SERVICE BULLETIN

M-1040

February 15, 1994

NEW CRUISE SET/RESUME AND CB PUSH-TO-TALK (PTT) SWITCHES

Figure 1. Removing Switch Actuator (Button)

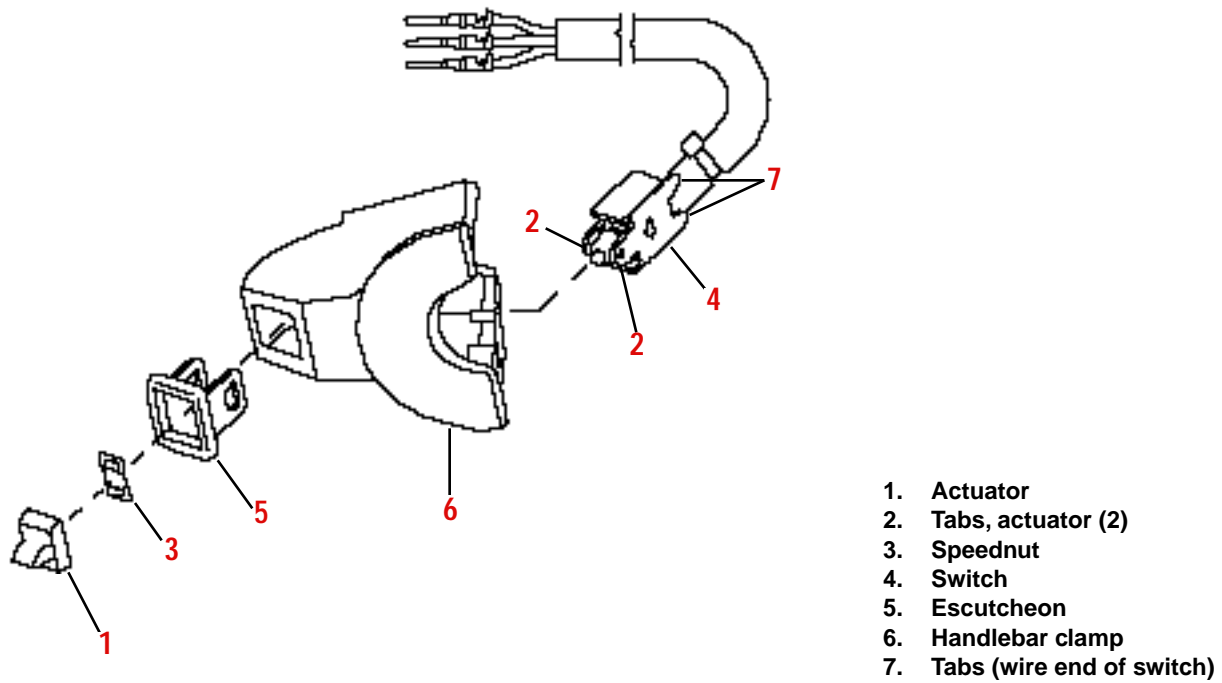
1. Remove the handlebar clamp and SET/RESUME switch following Service Manual procedures.
2. See Figure 1 and 2. Gently pry upward on the actuator (1) with a screwdriver to disengage the actuator pins from the holes in the switch tabs (2).
3. Gently pry the speednut (3) from the switch (4).

Figure 2. Cruise Control SET/RESUME Switch Assembly

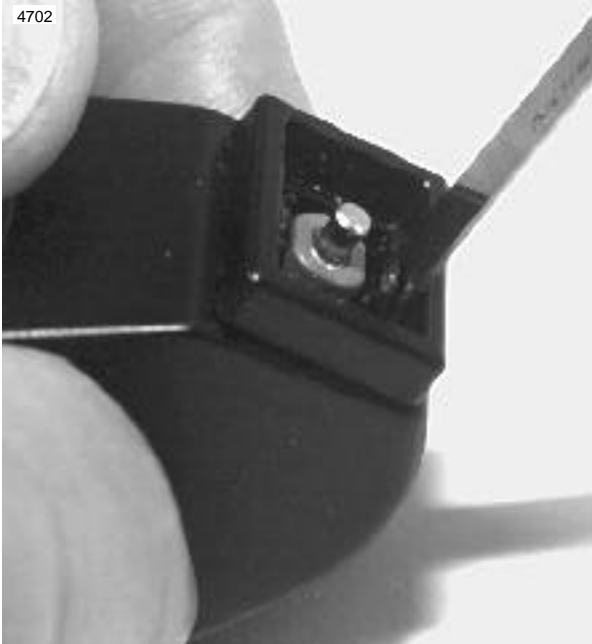
Cruise Control Set/Resume Switch Changes

Early 1994 Ultra's used Cable Assembly, Part No. 71585-94. This assembly had a switch, Part No. 77101-90A, that was not completely water proof. To prevent a water contaminated switch from generating false inputs, resistors were added to Cruise Control Harness, Part No. 70141-94.

Late 1994 Ultra's are equipped with a new sealed SET/RESUME switch which eliminated the need for the two resistors and the resistors were removed from the harness. Removal of the resistors changes the resistance values measured during troubleshooting. The new resistance values are given later in this Bulletin. The sealed switch and harness are being made available as a kit to allow retrofitting the sealed switch assembly to earlier models. The Part No. of this kit is 77101-90B. The harness with resistors, Part No. 70141-94, will continue to be sold for replacement purposes. The sealed switch assembly, in kit Part No. 77101-90B, will function properly with a harness containing resistors or with the later harness without resistors.

1. See Figure 2. Insert the escutcheon (5) into the handlebar clamp (6).
2. Insert switch (4) with side having two tabs (7) positioned as shown in Figure 2.
3. Press switch into escutcheon (5) until it latches into position.
4. Install speednut (3), place actuator (1) on switch rod and press until actuator pins enter holes in switch tabs (2).

Figure 5. CB Push-To-Talk (PTT) Switch Assembly

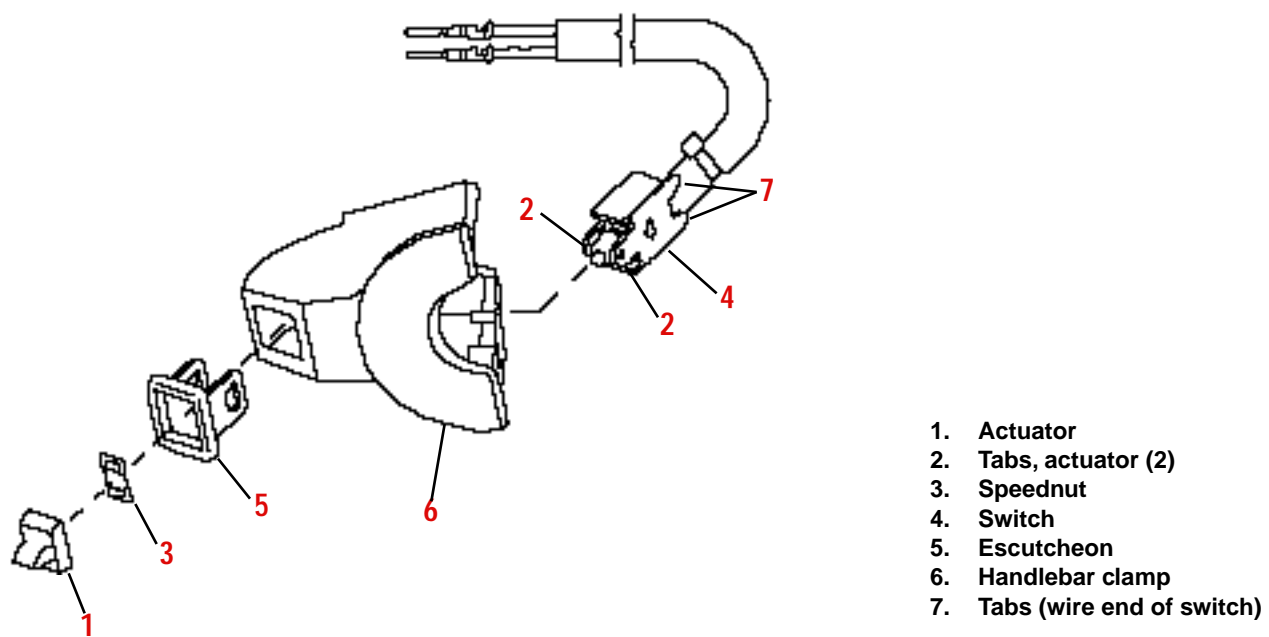
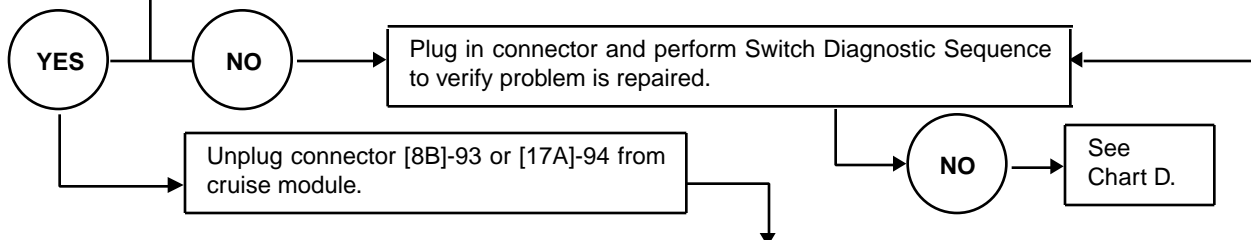
See Figure 5. On late 1994 models the PTT switch was changed to a sealed configuration. The new switch and harness is being made available in kit form under Part No. 77100-89B. Follow the REMOVAL/INSTALLATION given previously for the SET/RESUME switch to service the PTT switch. Detailed instructions for PTT switch will be covered in Instruction Sheet 77100-89B.

CHART A CRUISE TROUBLESHOOTING

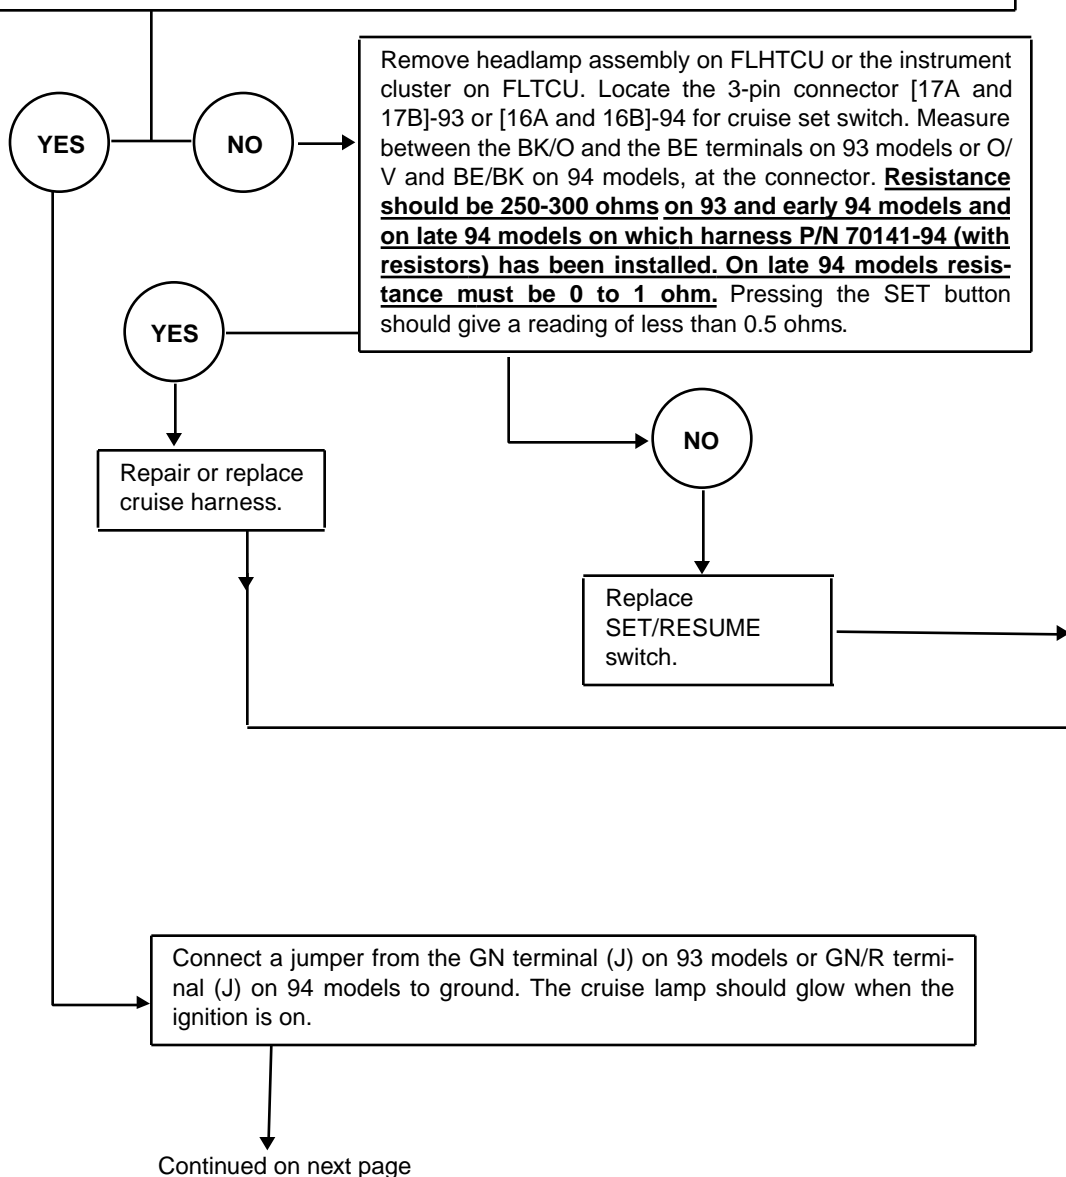
Check continuity between the BK/O terminal (F) and the BE terminal (B) of connector (8B)-93 or O/V terminal (F) and BE terminal (B) of connector [17A]-94. **Resistance should be between 250-300 ohms on 93 and early 94 models and on late 94 models on which harness P/N 70141-94 (with resistors) has been installed. On late 94 models resistance must be 0 to 1 ohm.** Pressing the set button should give a reading of less than 0.5 ohms.
